Step 4. Calculate the shell coefficients.

### 4.18.9.5 Calculation Procedure for Effect of Plasticity at Tubesheet/Channel or Shell Joint. (23)

**(d) Conical Channel [Note (4)]**

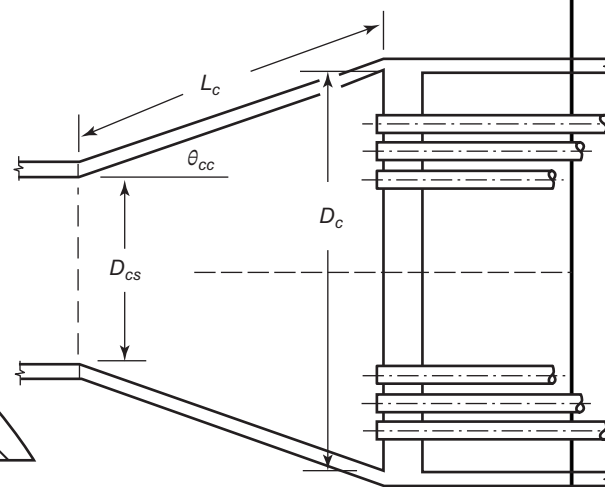
(4) Length of cone,  $L_c$ , shall be  $\geq L_{\min, c} = \sqrt{\frac{D_c t_c}{\cos(\theta_{cc})}} + \text{O.B.} \sqrt{\frac{D_{cs} t_c}{\cos(\theta_{cc})}}$

0.8
